Addendum 02

Date: 05-21-2026
Project: 22011 – Spin Lofts
 521 21st Ave
 Council Bluffs, IA

Spin Lofts
TD2#: 748-886
Addendum 2
05/15/2026

H9 TRASH ENCLOSURE - GATE ELEVATION
AS1.2 SCALE: 1/4" = 1'-0"

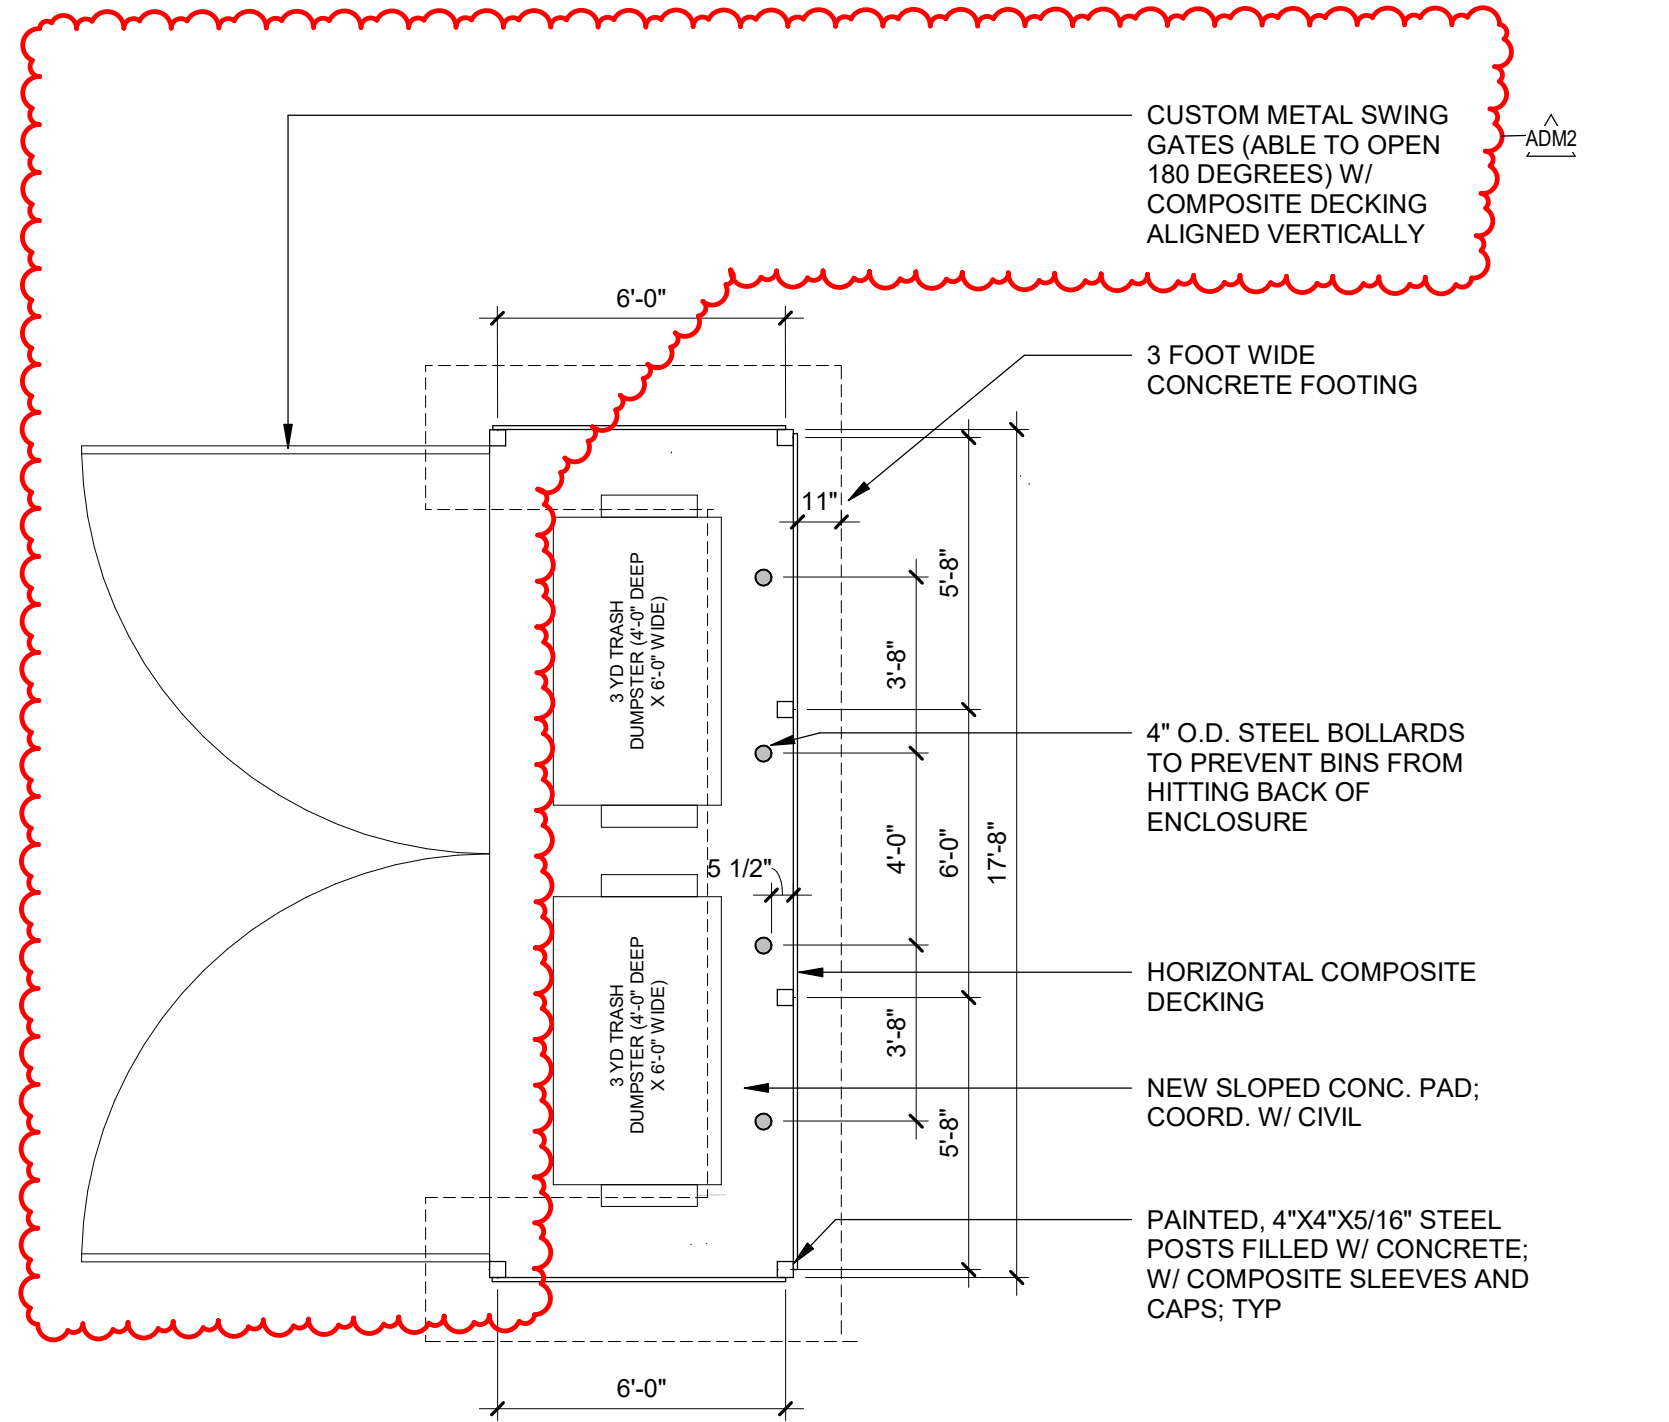
1. Sheet AS1.1: ARCHITECTURAL SITE PLAN
 - a. Add gates to trash enclosure.
2. Sheet AS1.2: ARCHITECTURAL SITE DETAILS
 - a. Add H9, trash enclosure gate elevation

E14 TRASH ENCLOSURE - PLAN
AS1.2 SCALE: 1/4" = 1'-0"

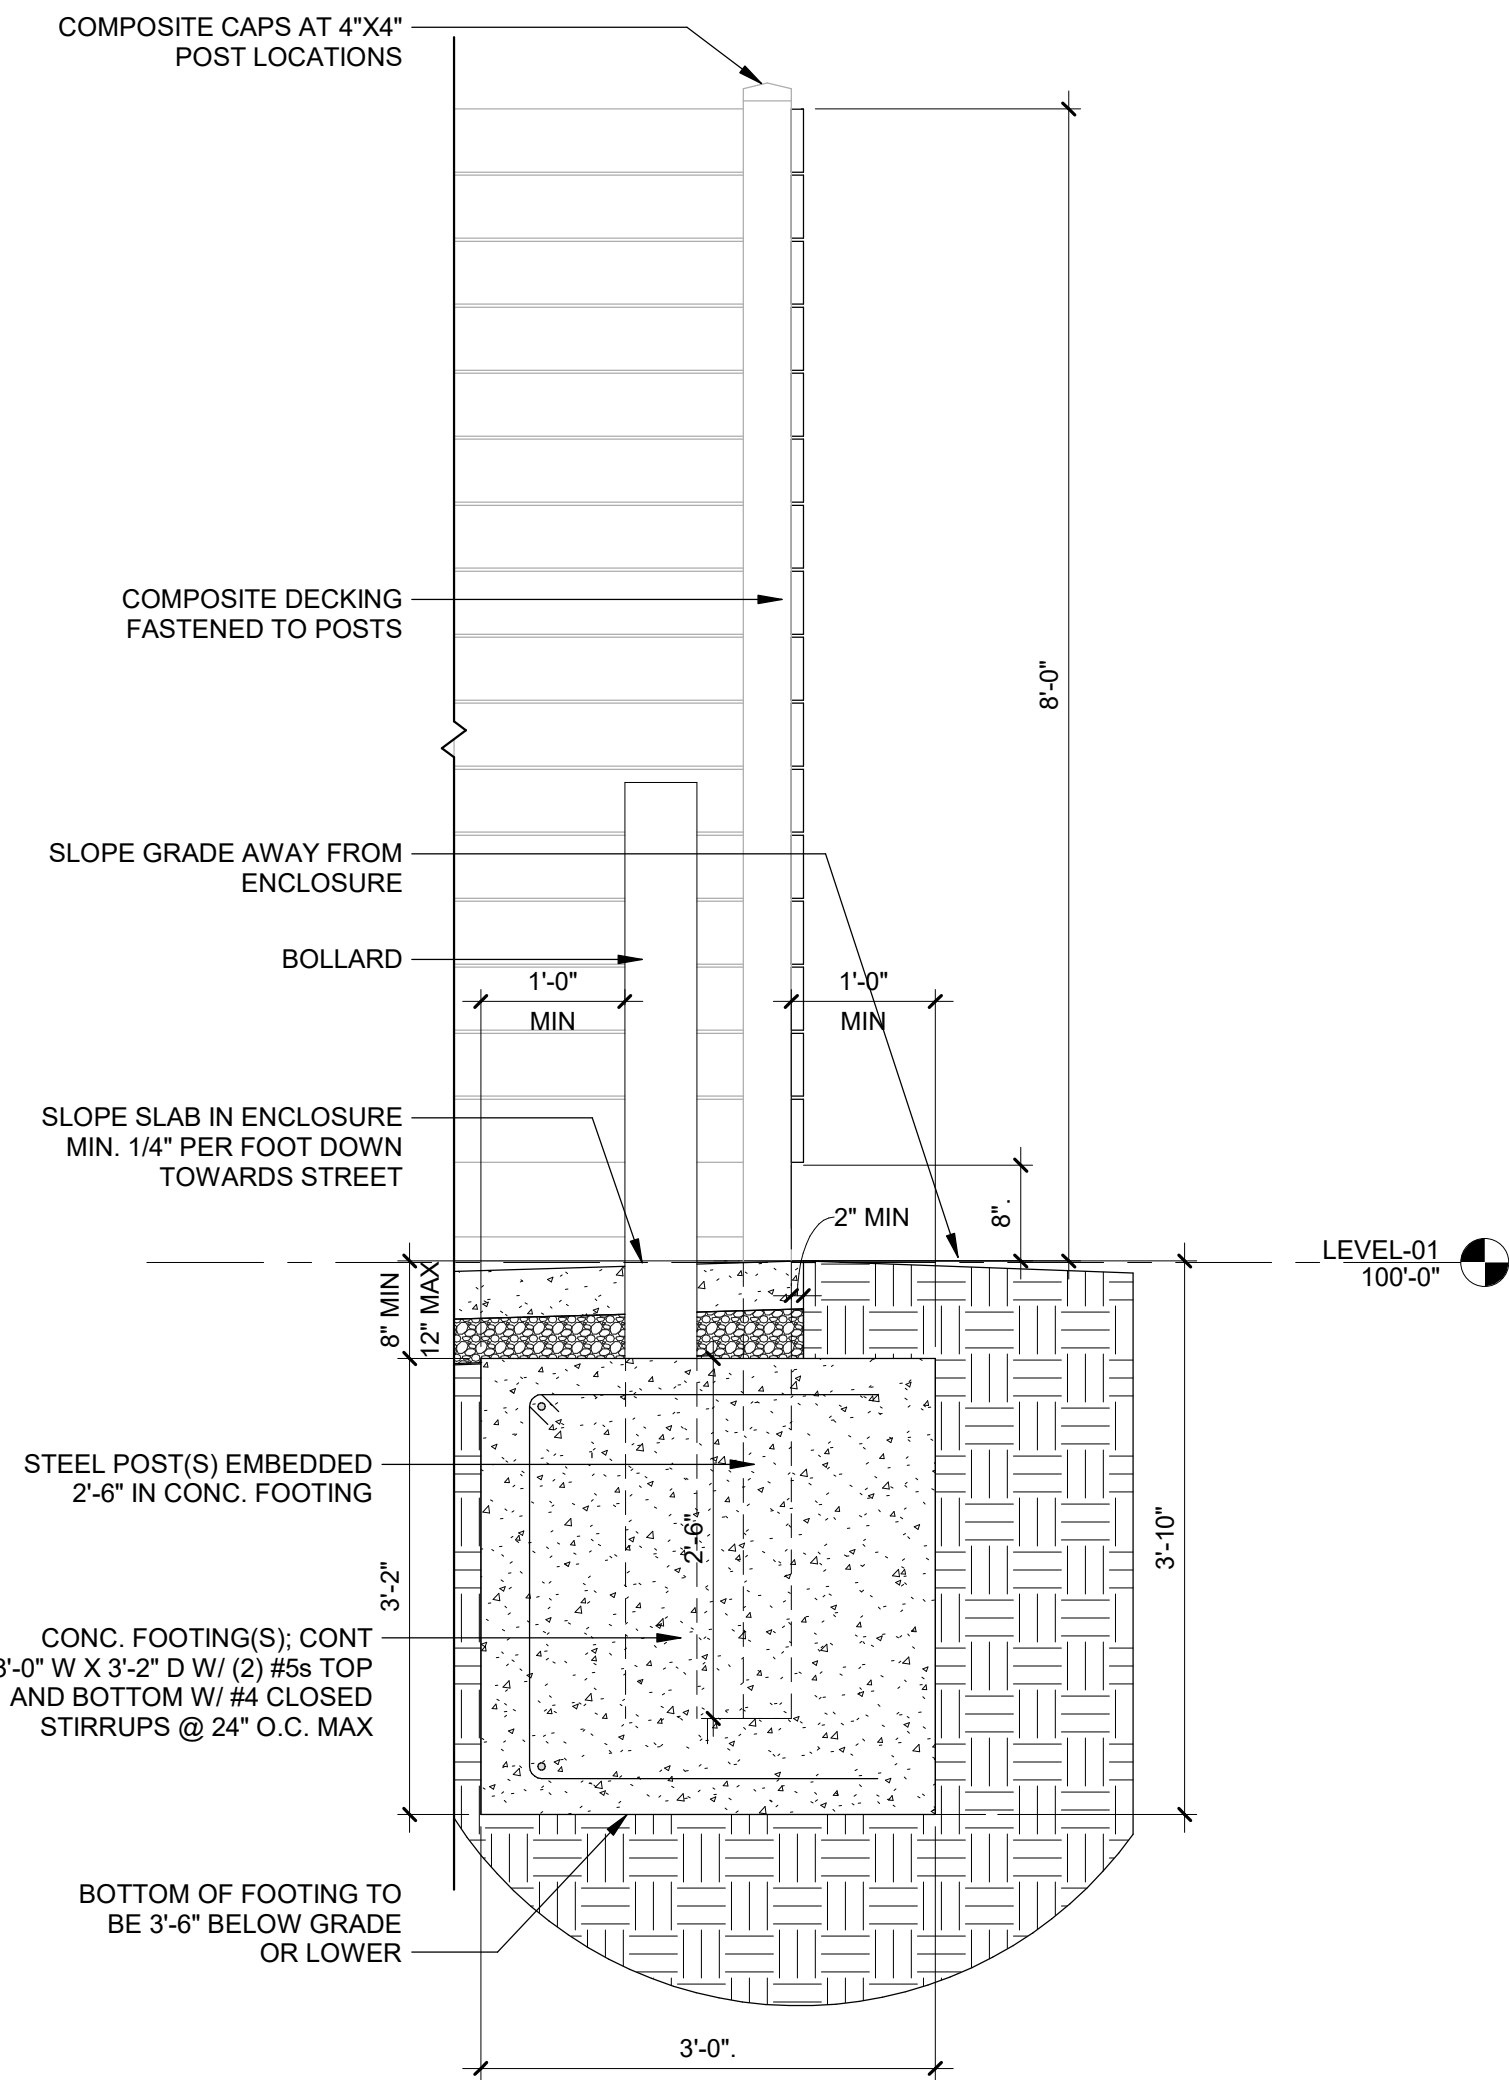
- b. Revise E14, trash enclosure plan to include gates at trash enclosure.
3. Sheet A0.0: BUILDING ASSEMBLIES
 - a. Revise placement of vapor retarder at roof assembly RF-2 (WD JOIST).

G1 FLOOR PLAN - LEVEL 01
A1.1 SCALE: 1/8" = 1'-0"

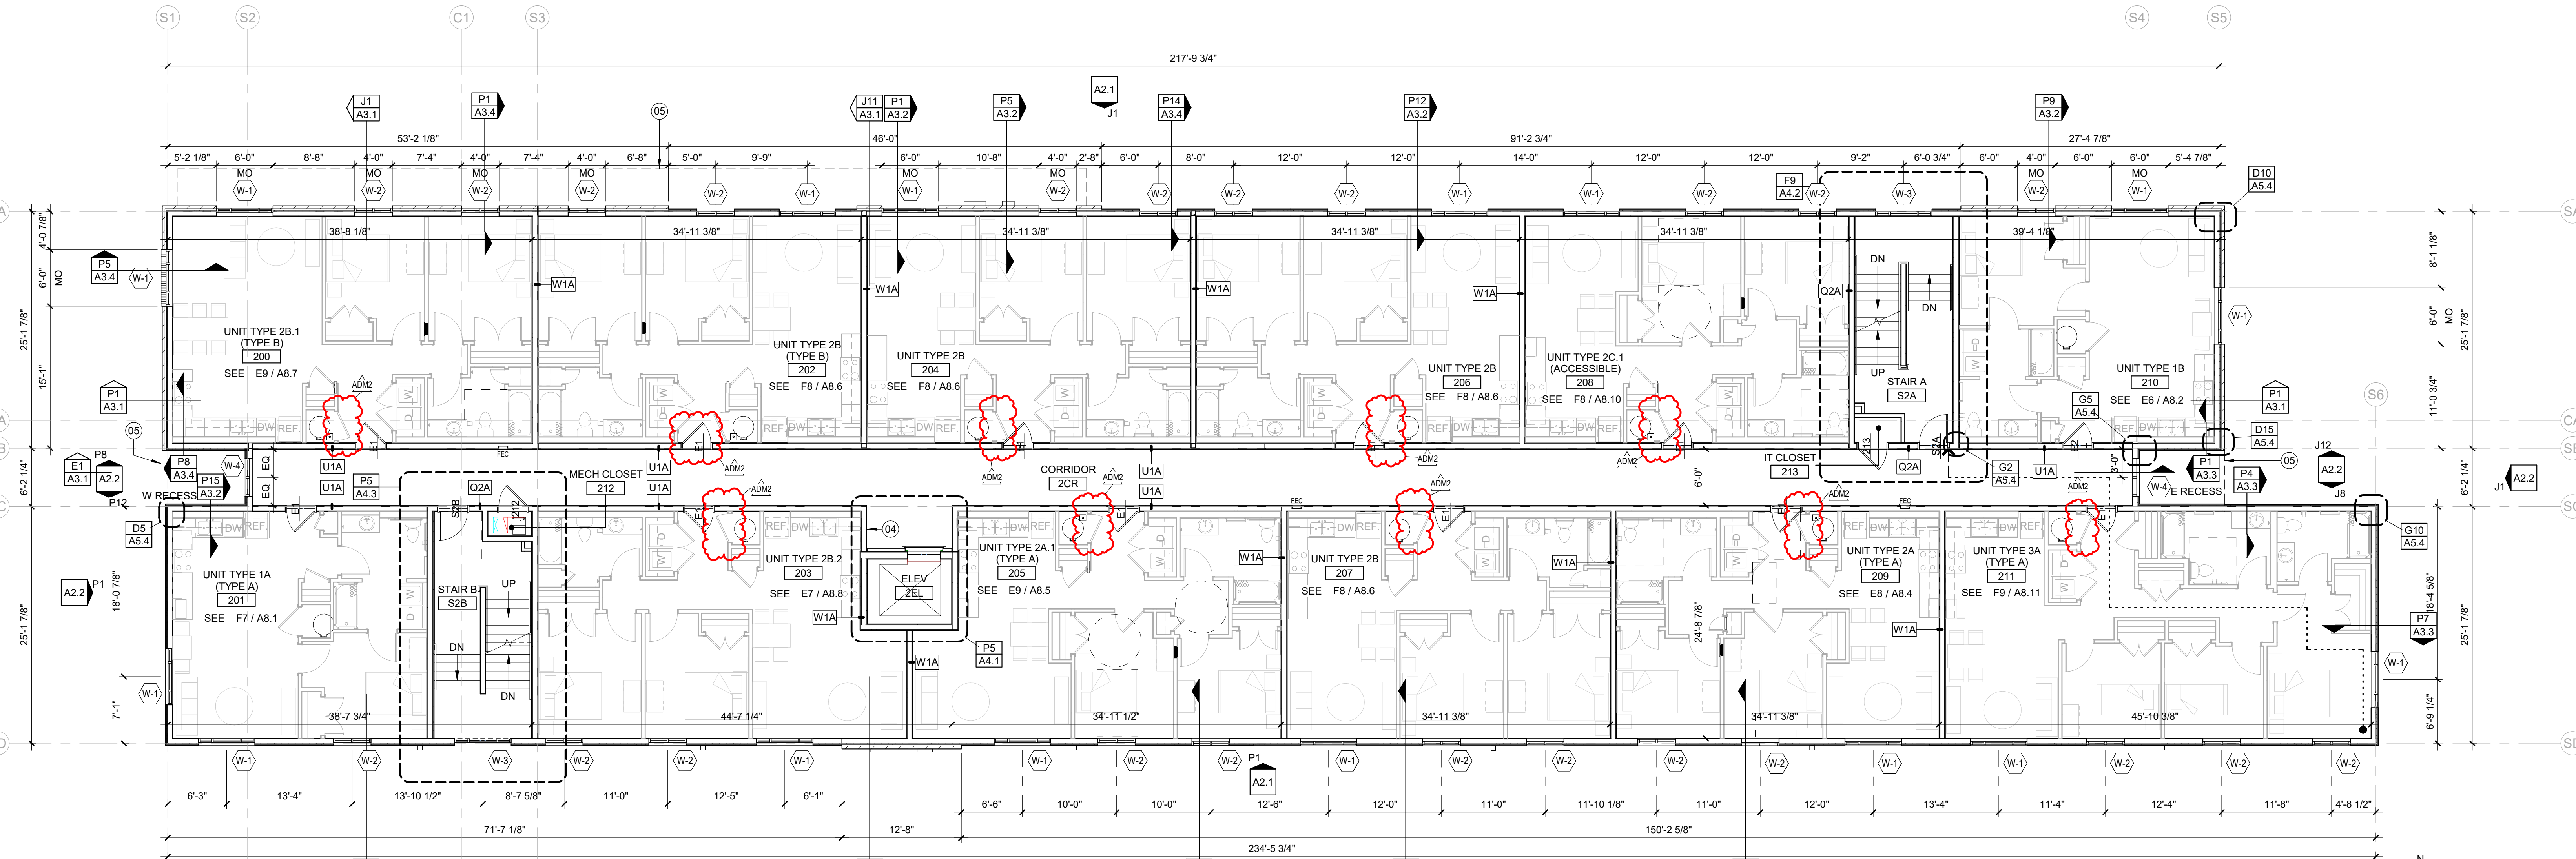
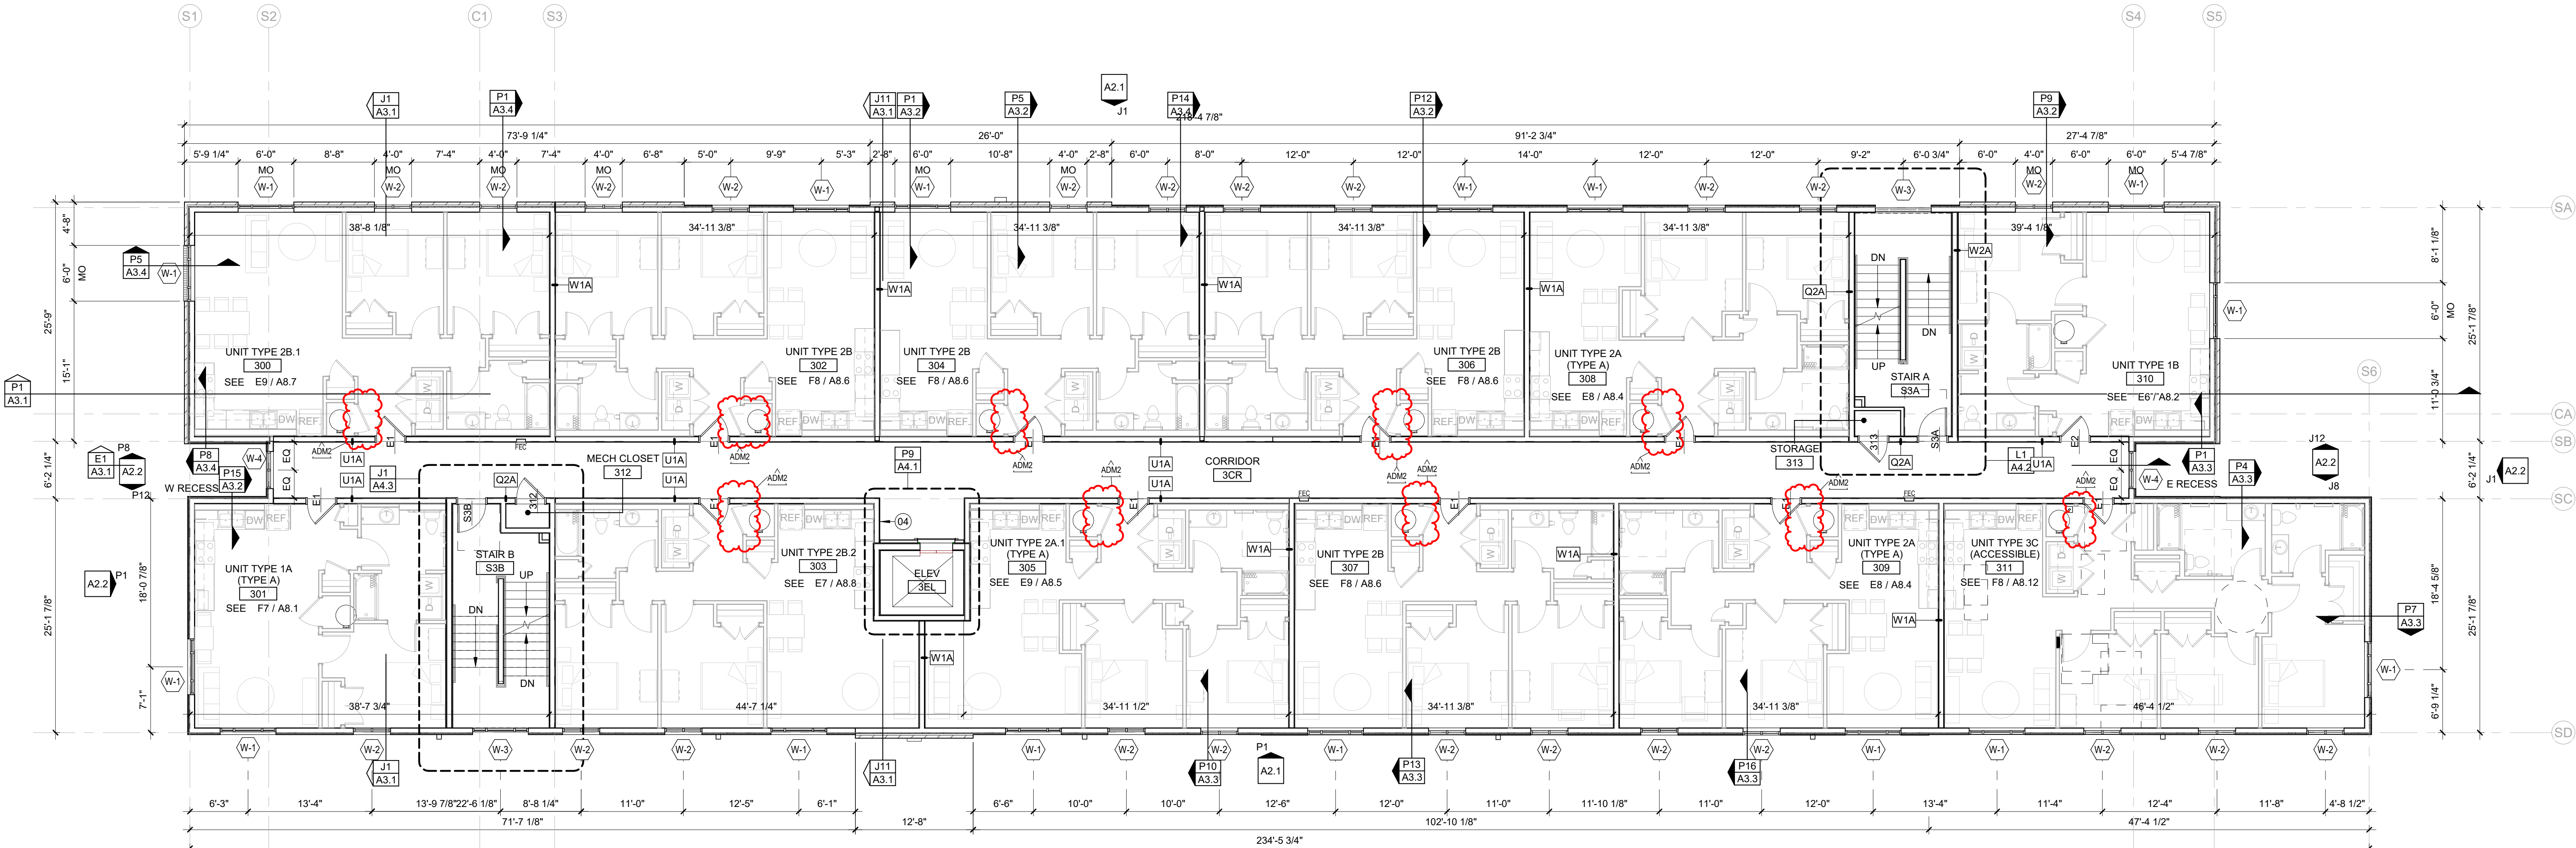
4. Sheet A1.1: FLOOR PLAN – LEVEL 01 & 02
 - a. Revise door swing at unit mechanical closets where noted on the floor plans.
5. Sheet A1.2: FLOOR PLAN – LEVEL 03 & 04
